RE: PD12-0003/Green Valley Convenience Center; Alternative Exhibits/Design Waiver Request (Revised Findings and Conditions of Approval)

DESIGN SUBMISSION
TO
COUNTY OF EL DORADO PLANNING COMMISSION

RE: S-12-0015 - Special Use Permit Application
PD-12-0003 - Planned Development Permit Application

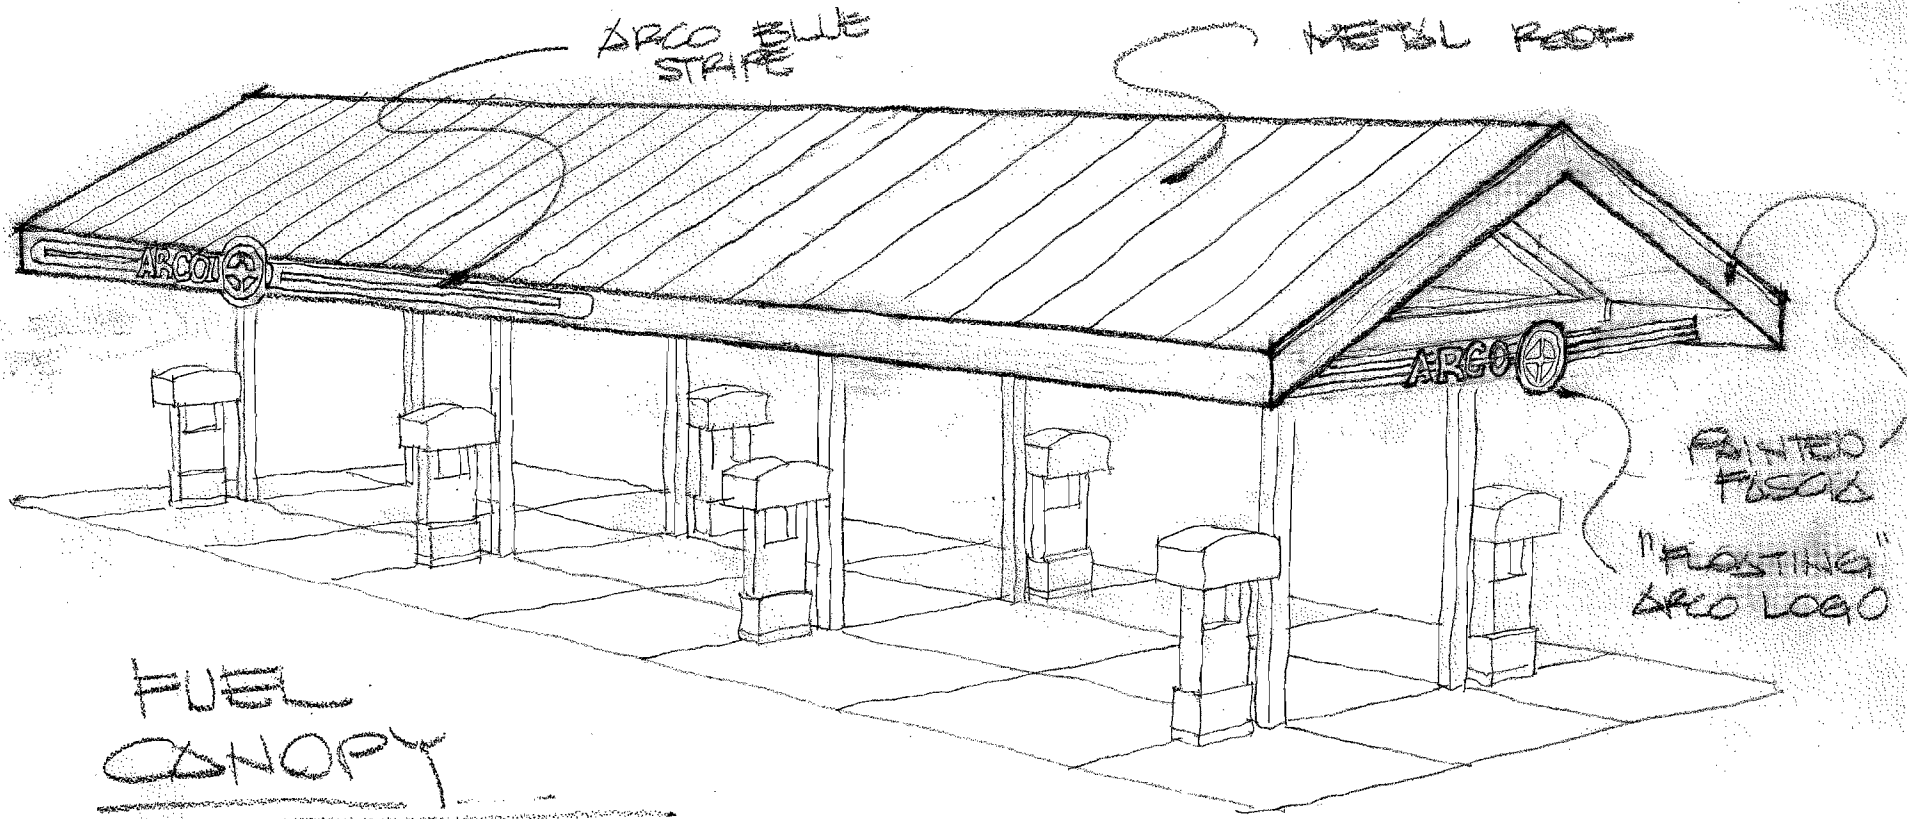
Responding to community requests, the attached sheets A2.1 and A2.2 – Exterior Elevations, together with the attached Color Board are intended to provide a design alternative to the previously submitted documents. While these sheets do not replace corresponding previously submitted documents, the alternative designs presented will be incorporated into the submission set if approved by the Planning Commission. The community had concerns about the potential for elevated noise levels coming from the drive-through ordering system associated with the proposed Schlotzsky's restaurant. To address this concern we retained Bollard Acoustical Consultants, Inc. to update their original report to include the effect of the ordering speakers on specific neighboring residential properties. This updated report is included in this submittal.

FUEL CANOPY

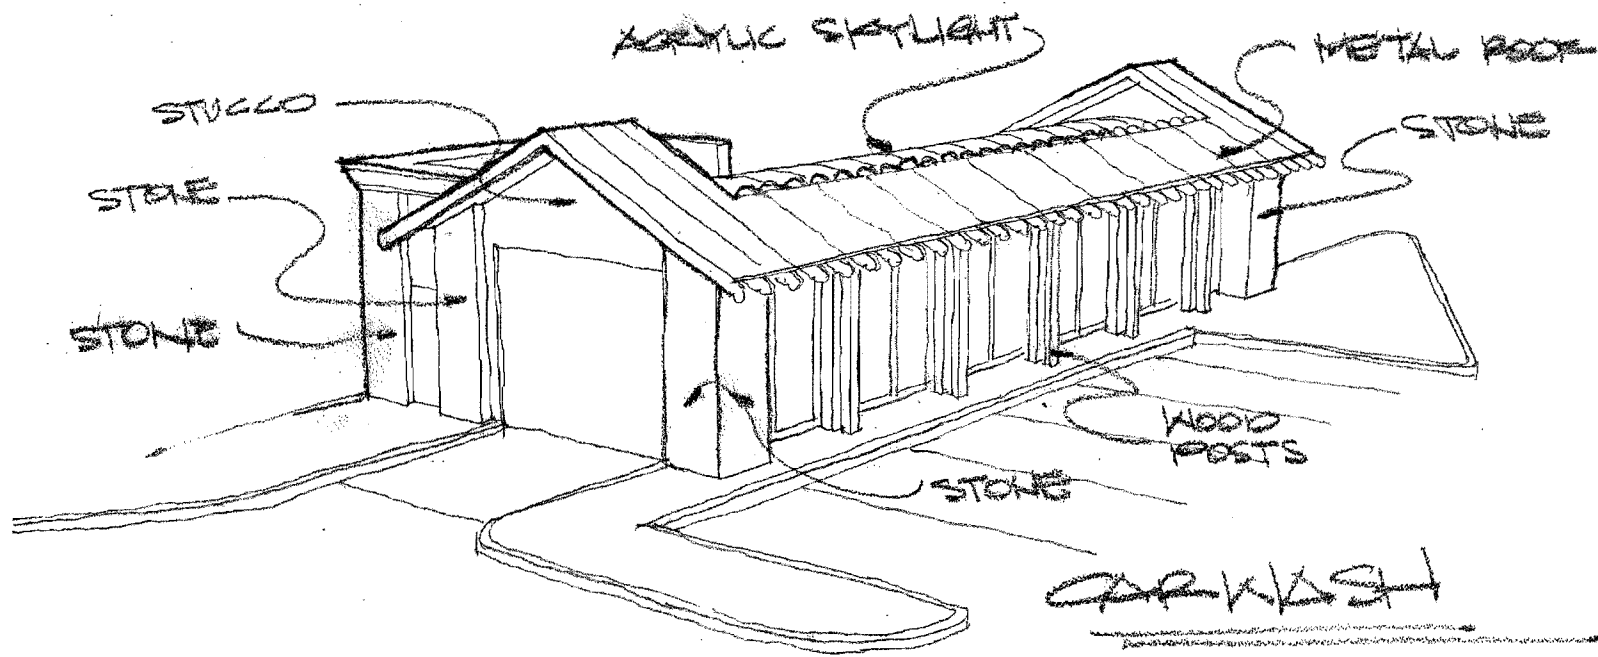
Responding to community requests, the attached preliminary sketch portraying the fuel canopy puts forth a design alternative. The attached sketch does not replace the previously submitted drawings, but serve to provide an alternative that, upon approval by the Planning Commission, will be incorporated into the project design.

SHEET NO. **TE.1**

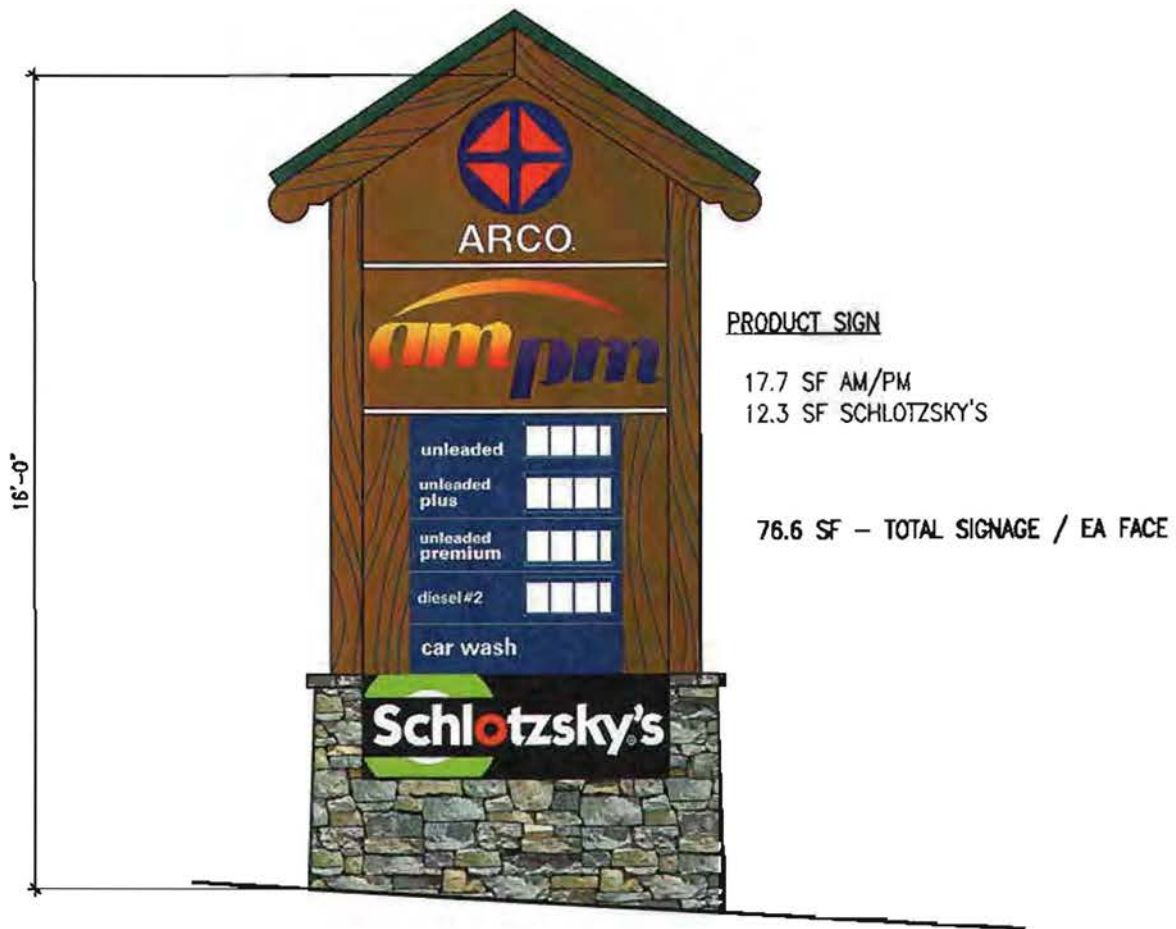
The attached sheet TE.1 – Trash Enclosure, elevations 1, 2, 4, and 6 presents the proposed design for a metal roof, material and color to match the roofs on the other proposed structures, as requested by the community. Upon approval by the Planning Commission, these elements will be incorporated into the project design.
